Safety Defect and Noncompliance Report Guide for Vehicles
PART 573 Defect and Noncompliance Responsibility and Reports (i)

Furnish the manufacturer's identification code for this recall (if applicable): 09E-013

K410 Identification Method

Fig 1

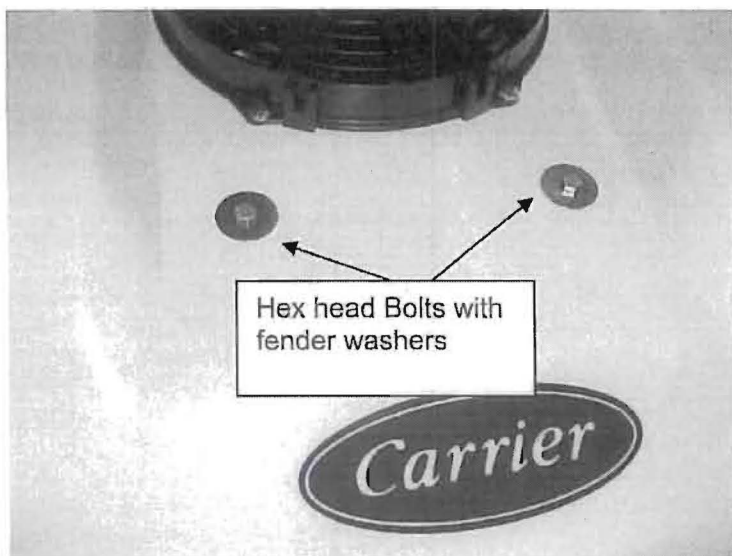
In order to check if your K410 rooftop condenser needs to be updated please look at the unit, if the cover is secured by Hex head bolts with fender washers (2 in the front and 4 in the back). Reference the Fig 1 below. If this is the case, then your unit was already retrofitted and **no further action is needed**.

Fig 2

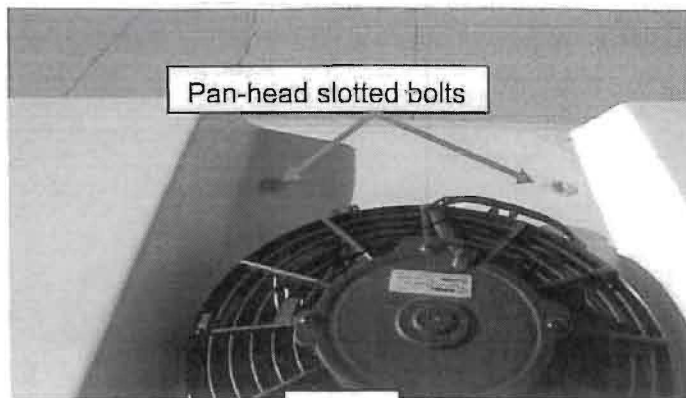
If the cover of your K410 is secured by Pan-head slotted bolts (fig 2), then it will need to have a, PN# 74-62047-00, retrofit kit installed by a Carrier authorized dealer or at your shop. Please call 1-800-450-2211 to have the retrofit kit(s) send. Carrier will pay all costs to have this kit installed on your unit(s). Please have the serial number(s) of the units(s) ready for our records.

Fig 3

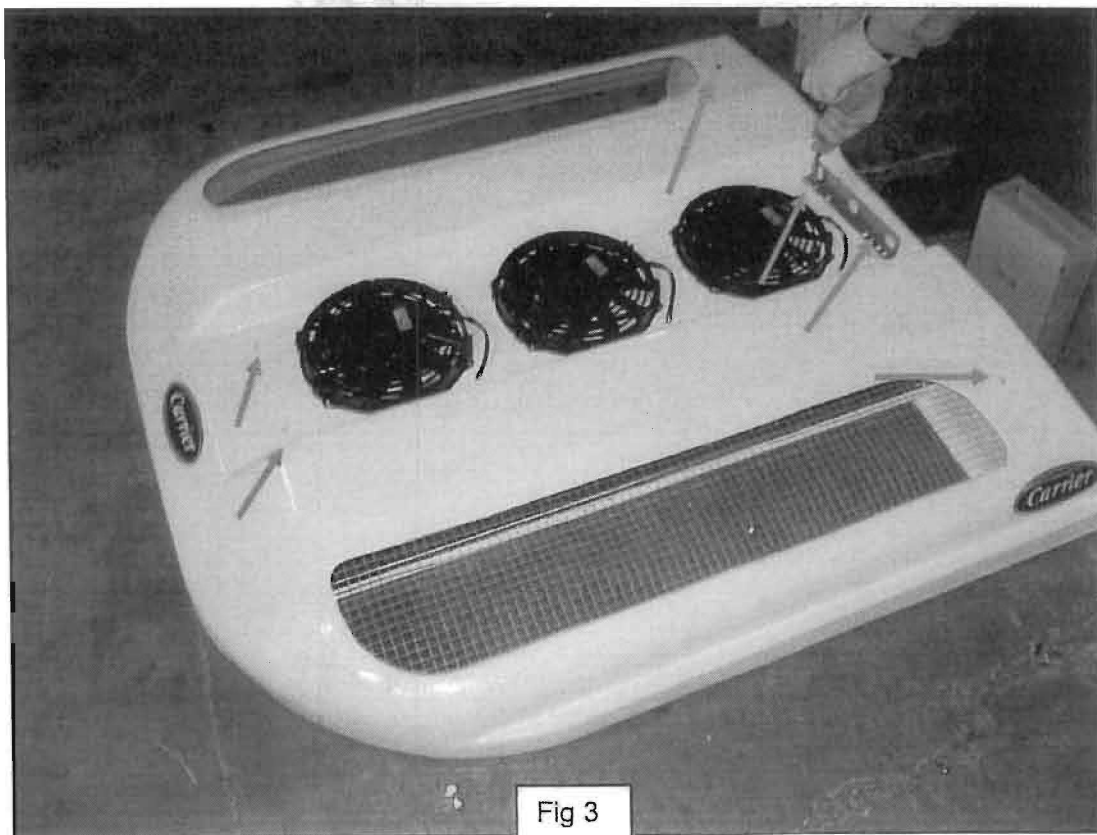
Remove 6 bolts, locations as seen in fig 3, lift cover and unplug 3 fan connectors, remove cover and store in a safe place until retrofit kit can be installed.
